ADDENDUM NO.3

PCHA-IFB-2023-05 GENERAL CONTRACTOR SERVICES - MAGNOLIA OAKS NEW CONSTRUCTION

ADDENDUM NUMBER 4

**PROJECT:
MAGNOLIA OAKS (PHASE I)
GMC PROJECT NO. ATAM200003**

A6.01

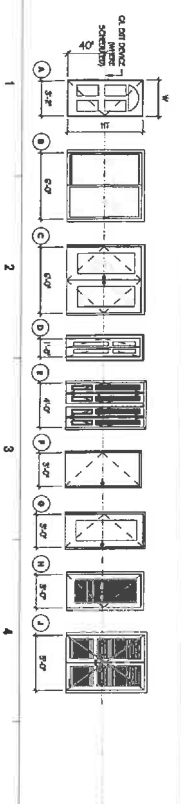
Question #1: The door type is missing from the bi-fold doors (i.e. 397, 399 etc.). Are they type D or E?

Question #3: Some bedrooms doors call for wood doors (207) & others hollow metal (396). Please advise.

Question #4: Some mechanical closet doors call for wood doors (630) & others hollow metal (728). Please advise.

Question #5: The mechanical closet doors call for flush door type F on A6.01; M112 calls for louvered doors. Please advise.

Question #6: The door frames are called out as welded hollow metal, which is unusual in wood framing. Typically, pre-hung doors are used in residential construction. Please advise if welded hollow metal frames are correct.

- Closet bi-fold doors are to be type E doors and pantry bi-fold doors are to be type D (see attached revised doors schedule)

- All interior doors are to be wood doors (see attached revised door schedule).

- All interior doors are to be wood doors (see attached revised door schedule).

- All mechanical closet doors are to be door type H (see revised door schedule).

- All interior doors are to have wood frames (see revised attached door schedule).
